Appendix A - Item 15

PPL Bell Bend Nuclear Power Plant
Salem Township, Luzerne County, PA

ACOE Information Requirement:

Figure 1.
Bell Bend NPP
Site Location Map

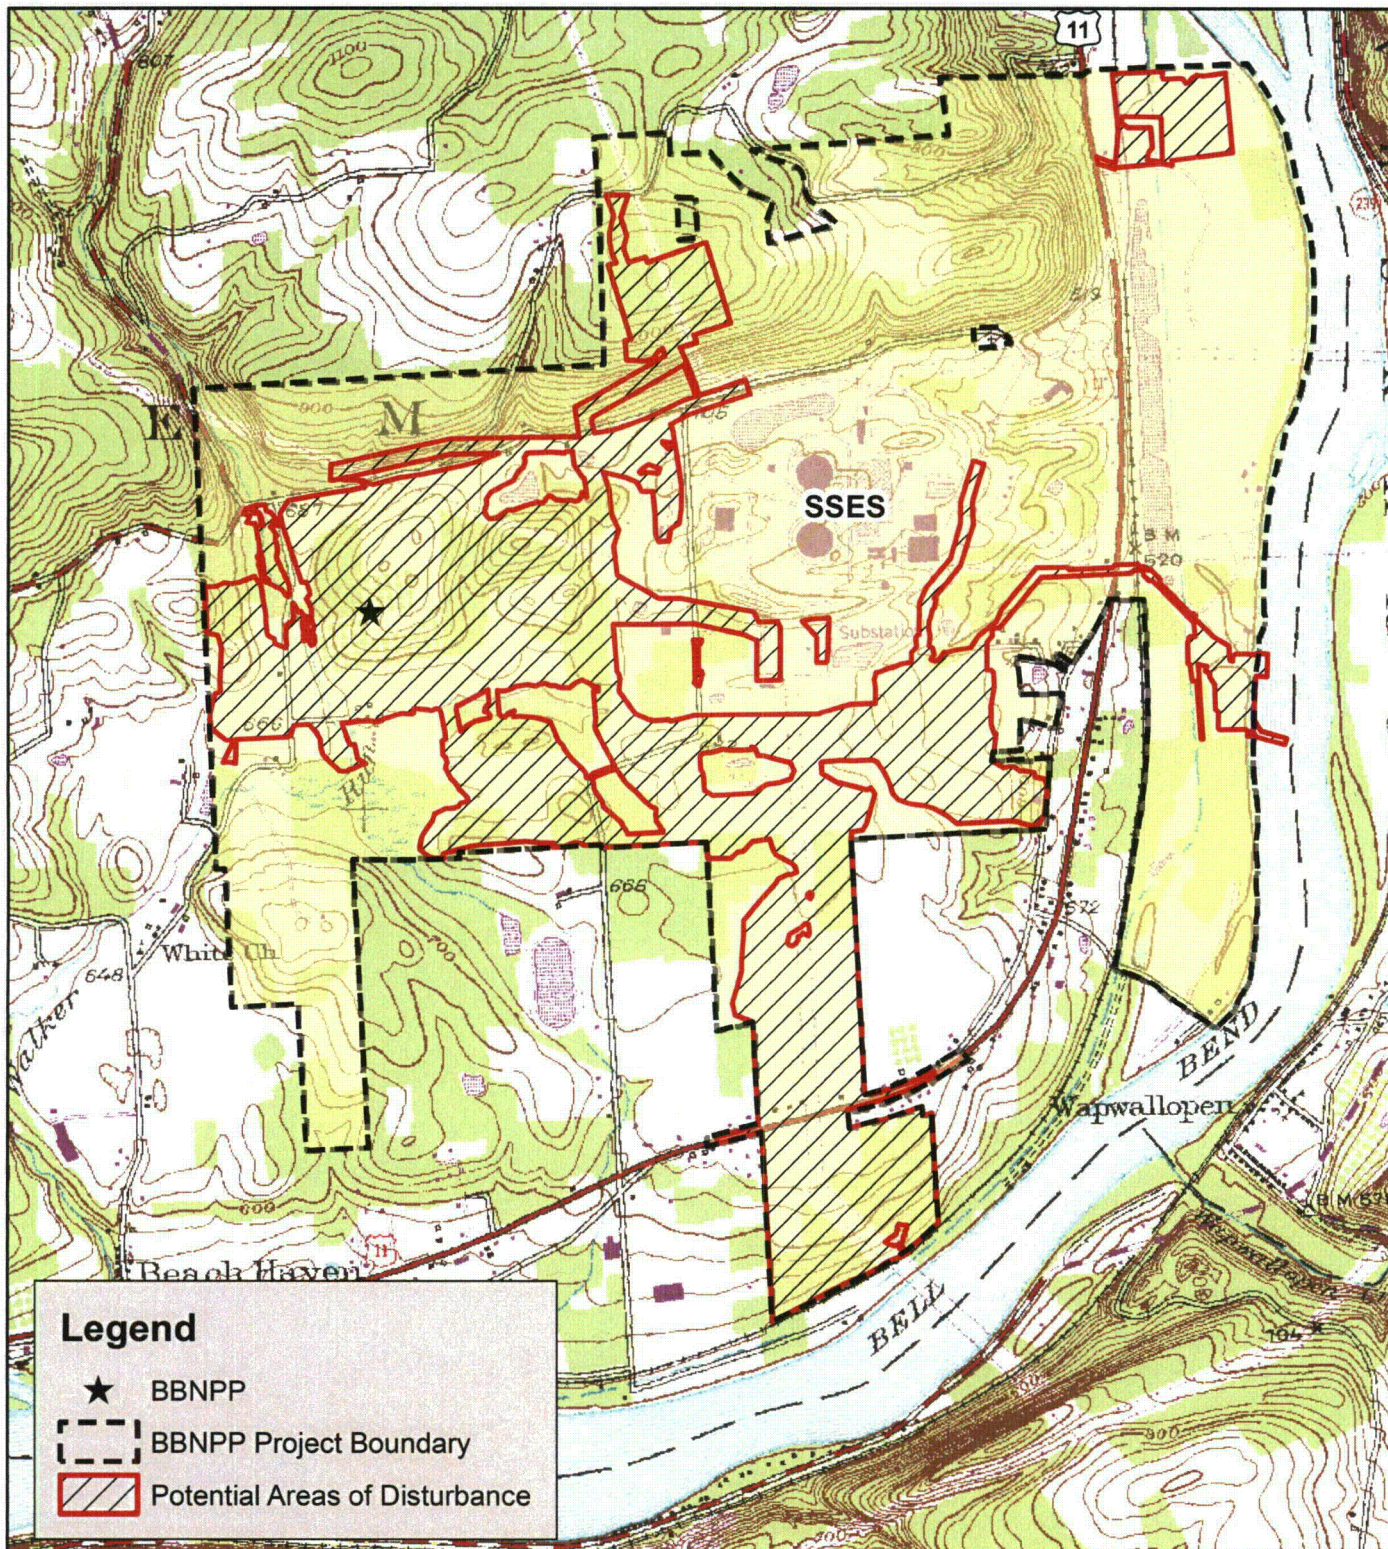
Overlay of the proposed plans on aerial photography (source and date indicated) and on maps showing wetlands of special state concern, NWI, county soil surveys, DNR wetland map, and topography.

See attached maps showing the site overlaid on the requested aerial photography and maps. See also Wetland Impact Maps in Section J, Enclosure D1 and D2
